[Docket No. 98-SW-74-AD; Amendment 39-11807; AD 2000-13-08]

Airworthiness Directives; Eurocopter Deutschland GmbH Model EC 135 Helicopters

ACTION: Final rule.

Figure 1

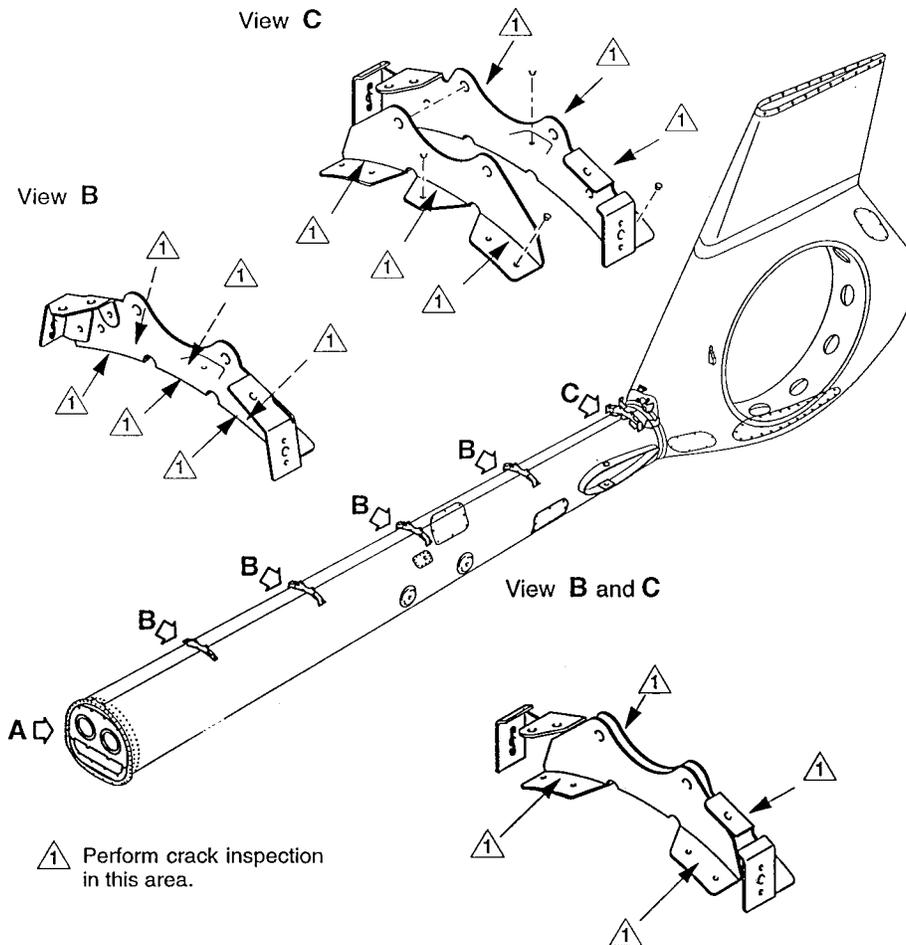
(1) Clean each tail rotor drive shaft bearing support. Using a 6-power or higher magnifying glass and a bright light, visually inspect the attach lugs of the bearing supports B and C (shown in Figure 1) for cracks, particularly in the area extending from the bend radius to the attaching screws and rivets connecting the bearing supports to the tail boom. Before further flight, replace each cracked bearing support with an airworthy bearing support.
